New Fractured Connecting Rod For 1989-2005 Caterpillar C7, 3114, 3116 & 3126 Engines

Main Bearing Bolt Torque Caution On '97-2005 Cummins ISX Signature 600 Series Engines

Enhanced Top Liner Cooling On '86-2005 Detroit Diesel 60 Series Engines

Figure 2 Cummins ISX 600 engine identification stampings.

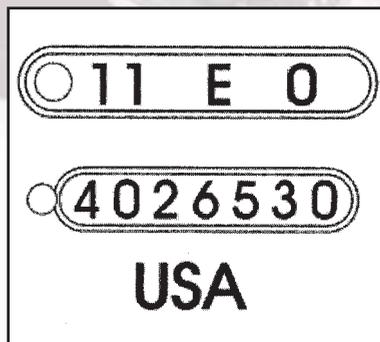
Engines that were manufactured up to engine serial number 79012120 can be identified with the letters "USA" (**Figure 2**, below) included in the stamping located just below the water pump. The torque value for those main bearing cap bolts is 110 ft.lbs. + 180°; use the sequence in **Figure 3** (below) for proper torque sequence.

Newer engines that were manufactured after serial number 79012120, can be identified by "MEX" and the pyramid mark stamped just below the water pump. The torque value for those main bearing cap bolts are 300 ft.lbs. + 90° using the sequence in **Figure 3** for proper torque sequence.

Figure 4 Enhanced top liner cooling feature on Detroit Diesel 60 Series engines.

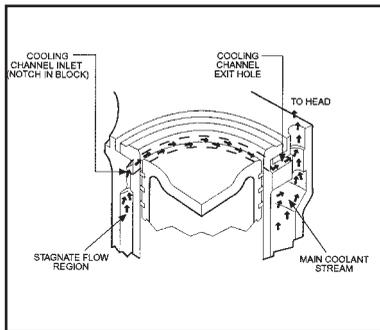
The AERA Technical Committee offers the following information regarding an enhanced top liner cooling on Detroit Diesel 60 Series engines. This feature, an option at the time of purchase, shown in **Figure 4**, page 32, was introduced to increase cooling to the top of the liner with serial number 6R59715.

To provide the benefits of the top liner cooling to engines built prior to 1994, a kit to retrofit these blocks is available (p/n J39582). Carefully follow the following procedure when converting a non-top liner cooling block to a top liner cooling block.

Figure 5 Install bronze washer on the feed unit shaft and attach cutter holder assembly to shaft.

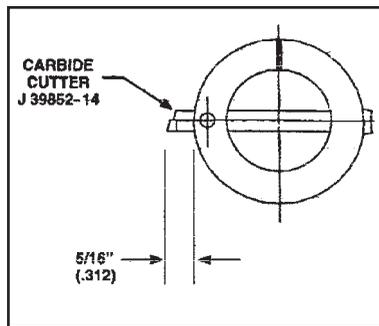
- 1) Assemble the scallop cutting unit together by mounting the feed unit to the base plate with screws supplied.
- 2) Install bronze washer on the feed unit shaft and attach cutter holder assembly to shaft. When installing the carbide

cutter into the holder, position it as shown in **Figure 5**, above.

Figure 6 Rotate the mounting plate 180° until it lines up with the next set of cylinder head bolt holes

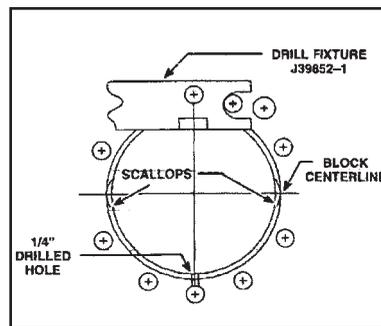
and by hand rotate the cutter away from the work. Remove the two mounting bolts and washers and rotate the mounting plate 180° until it lines up with the next set of cylinder head bolt holes as shown in **Figure 6**, above. Repeat steps until block is completely done.

Figure 7 The current head gasket design for Isuzu 7.1L engines has four blocked-off water coolant passages as compared to the original gasket.

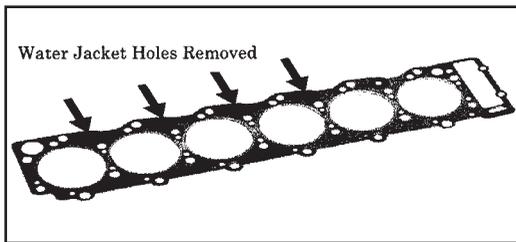
A new replacement cylinder head gasket for the 6HE1-TC diesel engine is currently available from the American Isuzu Parts Distribution Network (AIPDN). This new cylinder head gasket (p/n 8-94395-447-1), differs slightly from the original design. The difference between previous and the current gasket are very apparent visually and have prompted many questions from technicians who are re-assembling the engine. The current design, as shown in **Figure 7**, above, has four blocked-off water coolant passages as compared to the original gasket.

The holes were eliminated to improve coolant flow in the cylinder head and the new gasket replaces the original gasket p/n 8-94393-372-1.

When ordering a replacement cylinder head gasket, be sure to refer to the new part number listed in this bulletin. At the time of this publication AERA is unaware of an after-

Figure 8 Extra strengthening material was added to the Mack 12.0L timing cover.

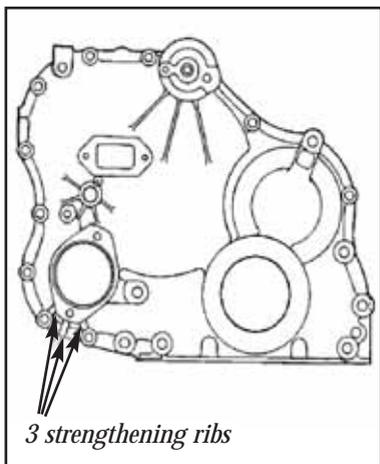
The AERA Technical Committee offers the following information regarding a revised timing cover for 2004-2005 Mack E-Tech™ 12.0L diesel engines. This revision was made to strengthen the power steering pump mounting flange to help reduce breakage and cracking on certain applications, particularly for engines used in vehicles equipped with the heavier Vickers model V20 power steering pump.

To provide strength, additional metal was added to the power steering pump mounting flange on both the inside and outside of the timing gear cover. With this change, the timing gear cover part number has been changed to p/n 333GB5131BM.

The most noticeable feature of this new timing gear cover is the three strengthening ribs located at the bottom of the pump-mounting flange as shown in **Figure 8**, (page 34).

New Part Number: 333GB5131BM

Description: Timing gear cover with strengthened power steering pump mounting flange, ASET™ AC, AI/AMI and E-Tech™ engines.

Replaces Part Number: 333GB5131AM

Figure 9 Pre-2000 and revised main bearings for Navistar 7.6L and 8.7L engines.

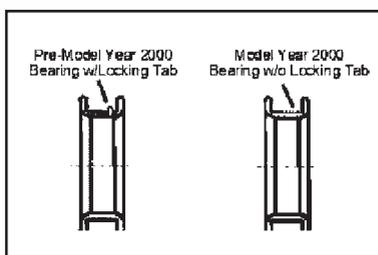
This unwarranted confusion is the result of a revised bearing introduced with the model year 2000 engines. The new lower thrust main bearing (#7 position only) was released for production and service for ease of installation.

The bearing was modified by removing the locking tab as depicted by the illustration in **Chart 2**, bottom.

service bearing allows the lower thrust bearing to be installed and oriented in either direction (see **Figure 9**, above). Service bearing for lower main bearings 1-6 and crankcase (upper 1-7) continue to require bearings with the locking tab feature.

The modified bearing is interchangeable with engines released before the Model Year 2000 engines. Model Year 2000 engines are identified by serial number 1194039 and above. Service bearings are available in standard and three common undersizes. **EB**
